DRAINAGE PLAN AND REPORT

ROCKY TOP MOTEL AND CAMPGROUND

EL PASO COUNTY

Add PCD File No. PPR2140

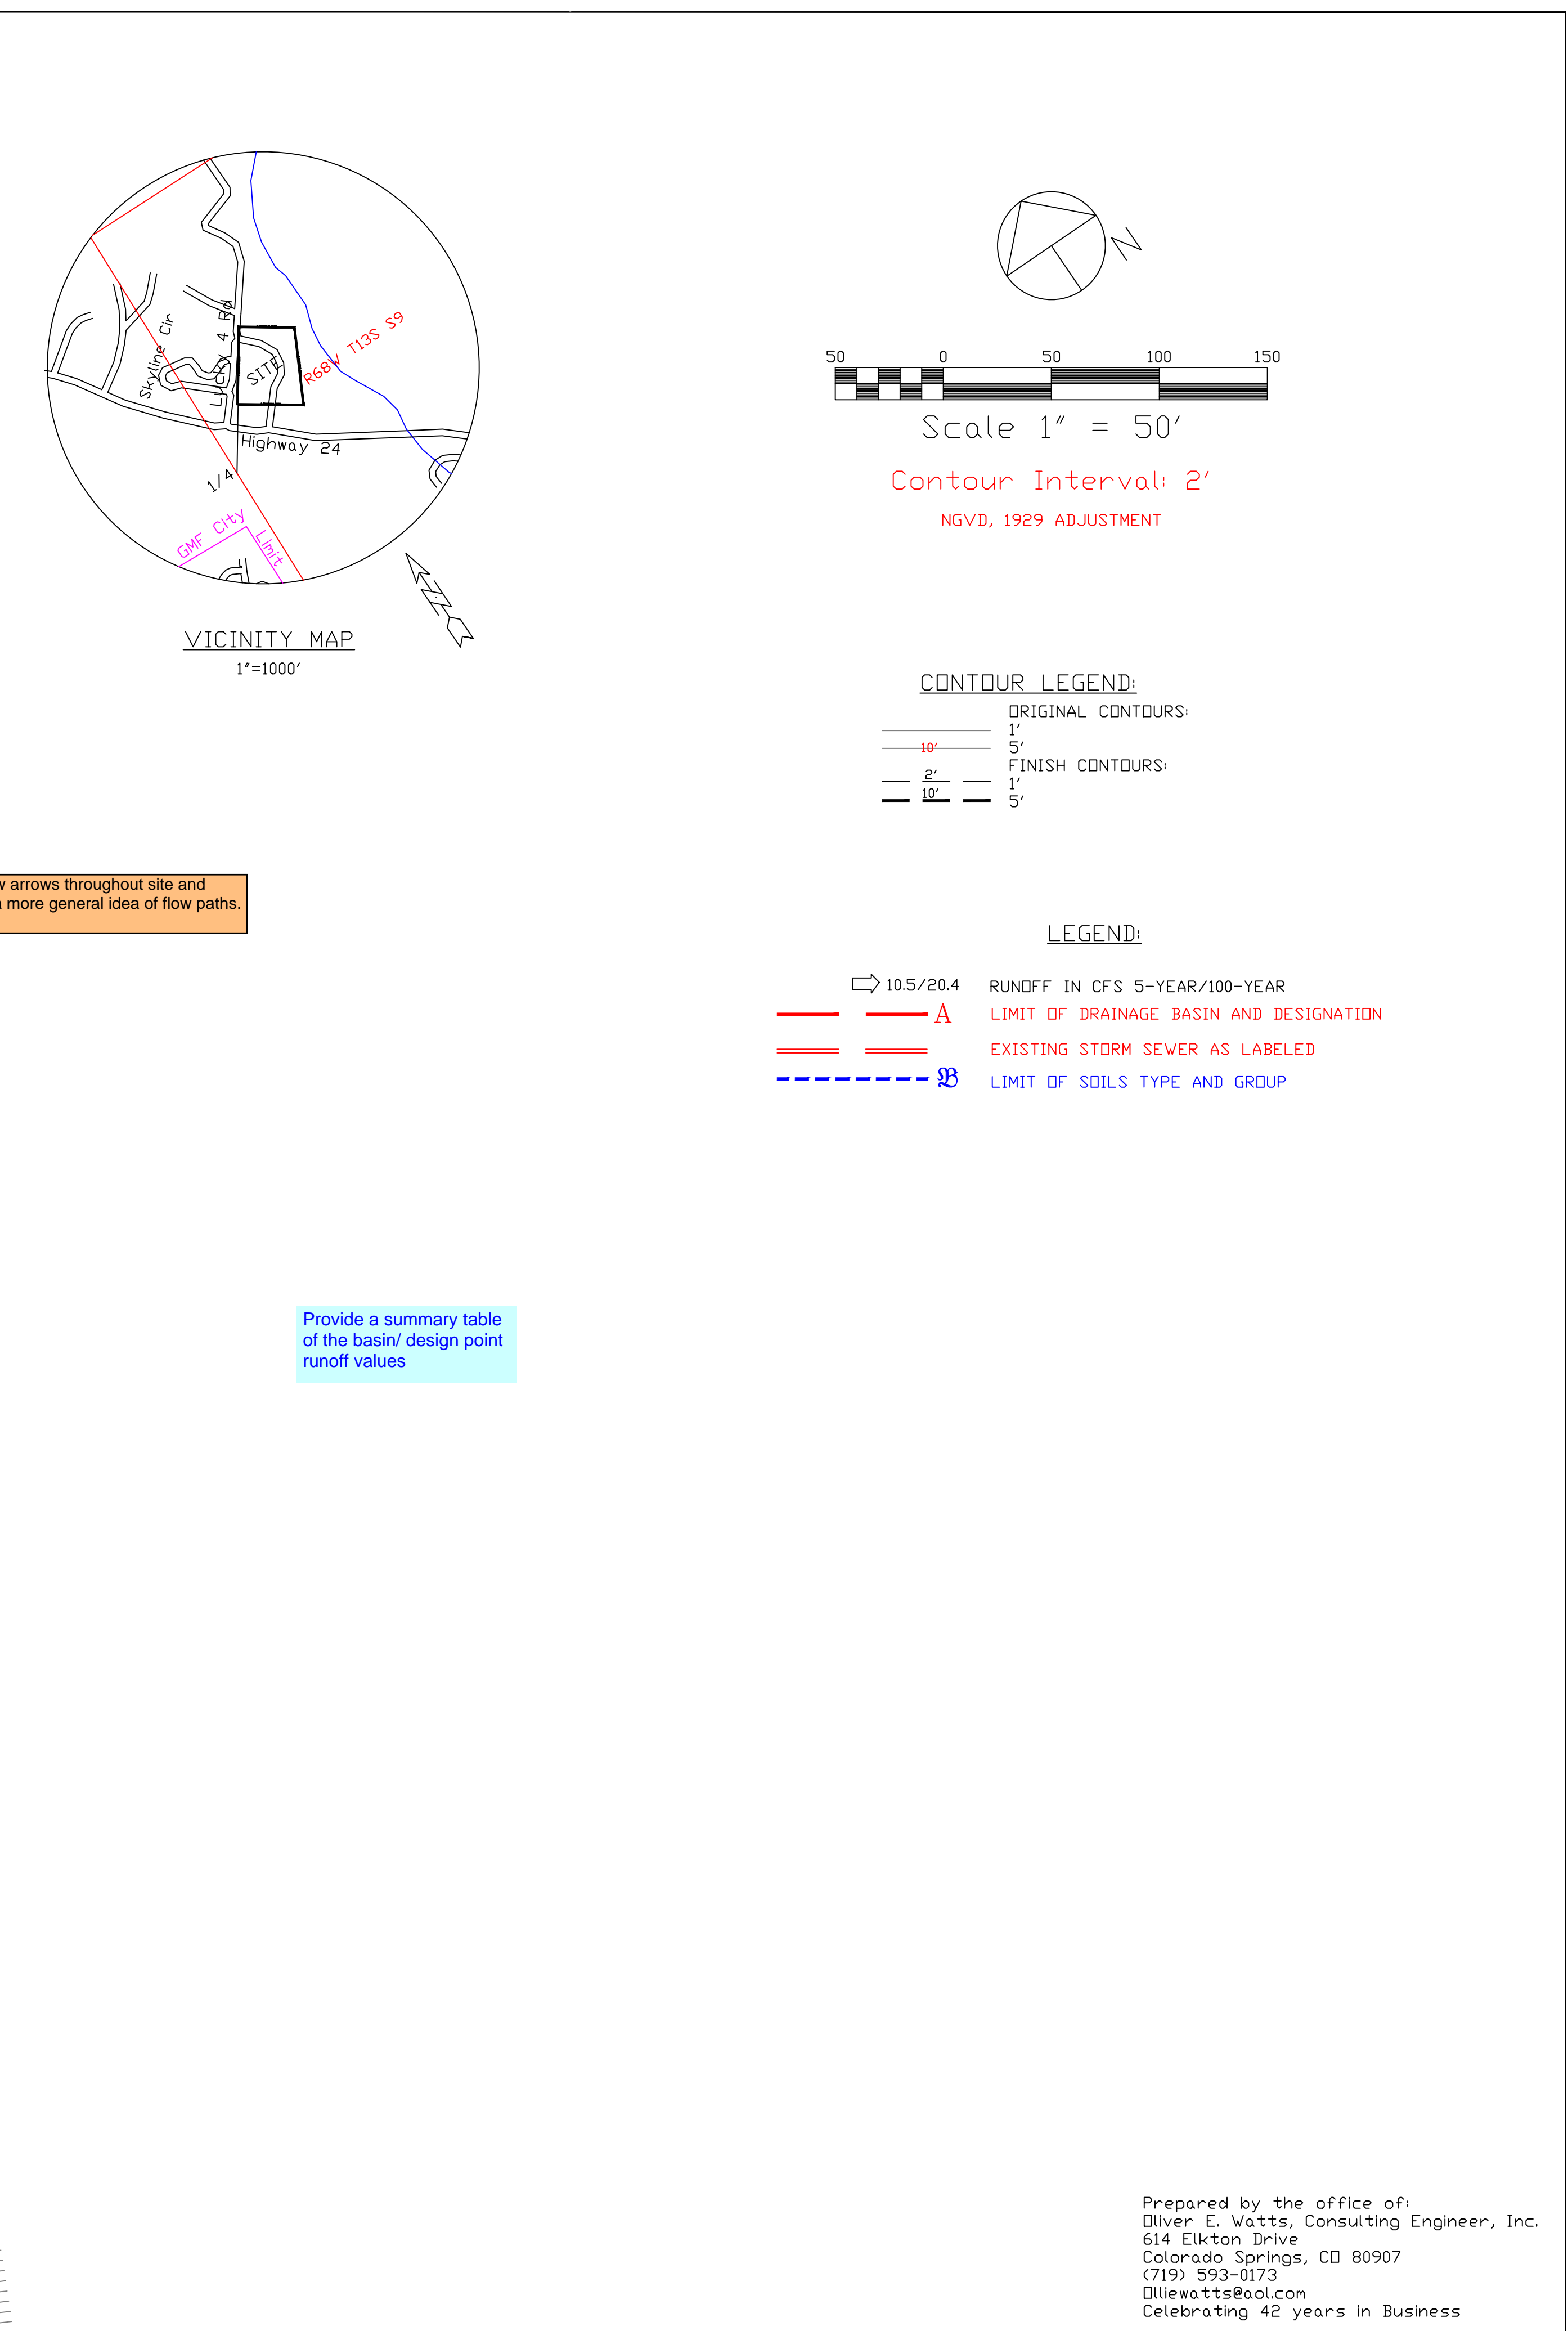
Please show this
culvert on the
drainage plan
